ADDENDUM #2

HIGHLAND 1,000,000 GALLON ELEVATED WATER STORAGE TANK

City of Duluth, Minnesota

**ADDENDUM #2
HIGHLAND 1,000,000 GALLON ELEVATED WATER STORAGE TANK
CITY OF DULUTH
PROJECT 0768WA
BID NUMBER 10-0314
JUNE 25, 2010**

SHEET No.
AD2-1 of 1

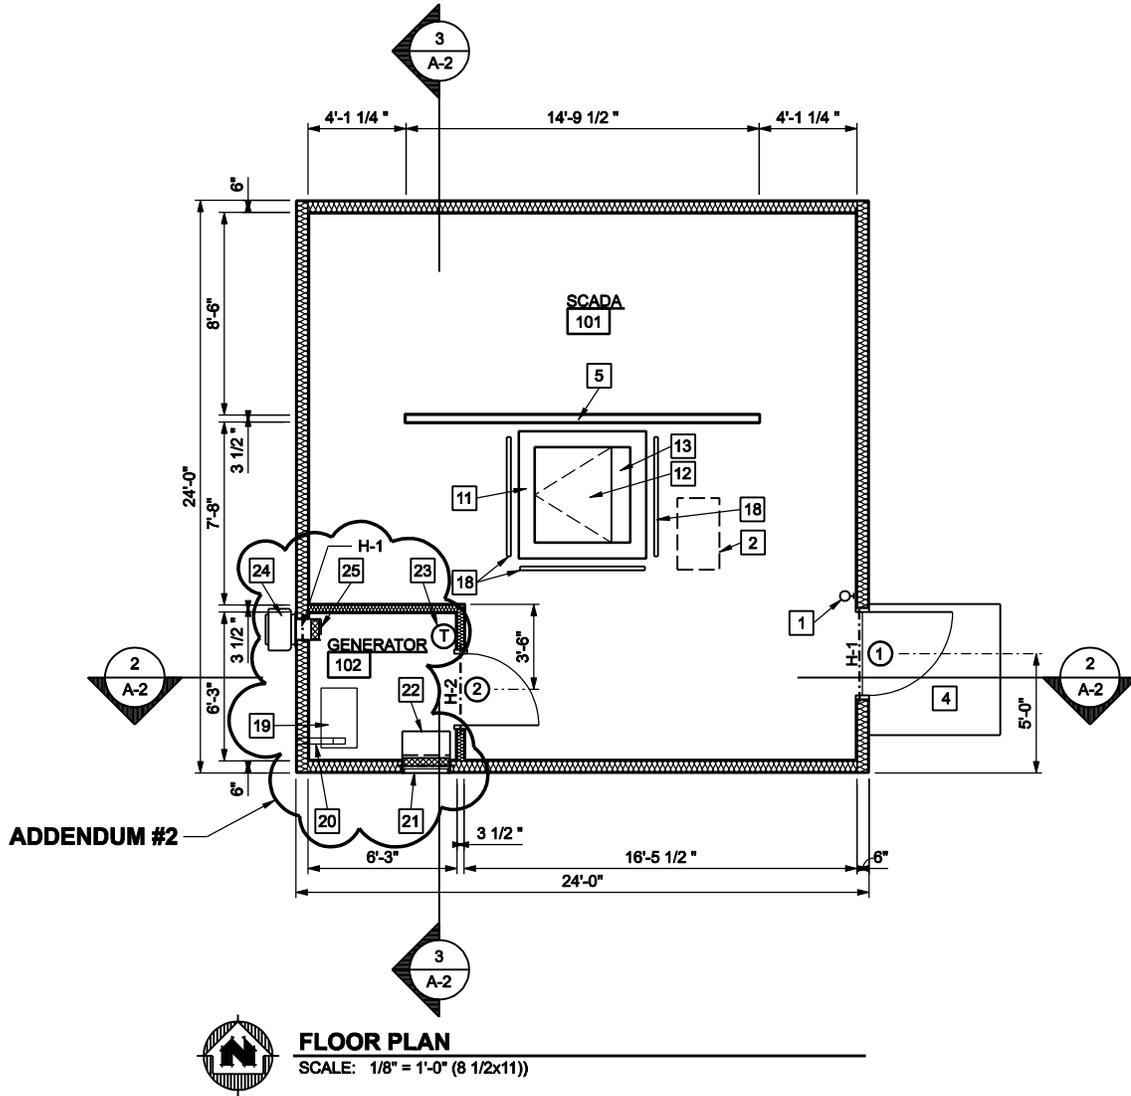
Floor Plan: Reference the attached Sheet No. AD2-1 of 1, dated 6/23/10, for revisions to the Floor Plan. The following is a written description of the changes.

- ADD** Exhaust fan on west wall of Generator Room 102. Fan shall be Greenheck CW-095-D (or equal by Acme, Cook or Penn), 760 CFM at 0.13" SP, with speed control for balancing. Damper shall be Greenheck VCD-34 (or equal). Actuator shall be Belimo power open, spring close. Fan shall be activated when thermostat calls for cooling. Damper shall be 100% open when fan is activated.

- ADD** Prefinished louver on south wall of Generator Room 102. Louver shall be Greenheck EDJ-202 (or equal by Carnes, Cesco, Greenheck, or Ruskin), 24" wide by 24" high, Kynar 500 finish in manufacturer standard color. Damper shall be Greenheck VCD-34. Actuator shall be Belimo power open, spring close. Damper shall open 100% when either fan or generator is activated.

- ADD** Thermostat shall be mounted 4'-0" AFF where shown. Thermostat shall be cooling type, 3-5 degree F range, 65-100 degree set point range.
- ADD** Existing generator shall be relocated – see Electrical. Relocate existing duct and wall hood.
